**U. S. NUCLEAR REGULATORY COMMISSION
TECHNICAL EVALUATION REPORT FOR
THE U.S. DEPARTMENT OF ENERGY IDAHO
NATIONAL LABORATORY SITE
DRAFT SECTION 3116 WASTE DETERMINATION FOR
IDAHO NUCLEAR TECHNOLOGY AND ENGINEERING
CENTER TANK FARM FACILITY**

October 2006

Figure 20. Cross Section of Final Calibrated Model (From DOE Idaho, 2006c)

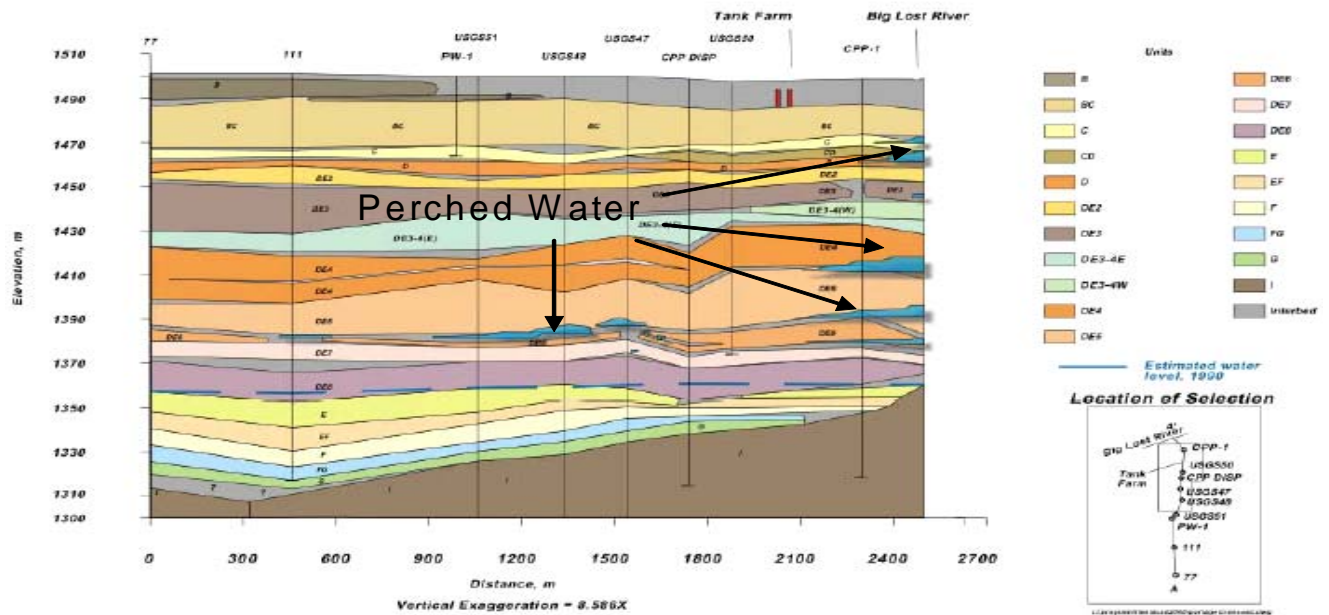
The final calibrated model (DOE Idaho, 2003a, see Figure 20) results are inconsistent with the current extent of the perched zone based on recent monitoring data (DOE Idaho, 2006d). The northern, shallow perched zone has persisted even in the absence of the percolation and wastewater treatment seepage ponds (see Section 4.2.4). Thus, the final calibrated PA model does not appear to be well-calibrated with respect to present-day perched water-levels. The source of current perched water may be both precipitation infiltration and service water leakage and thus, the effects of perched water on contaminant flow and transport over long time periods after operations at INTEC cease is uncertain.
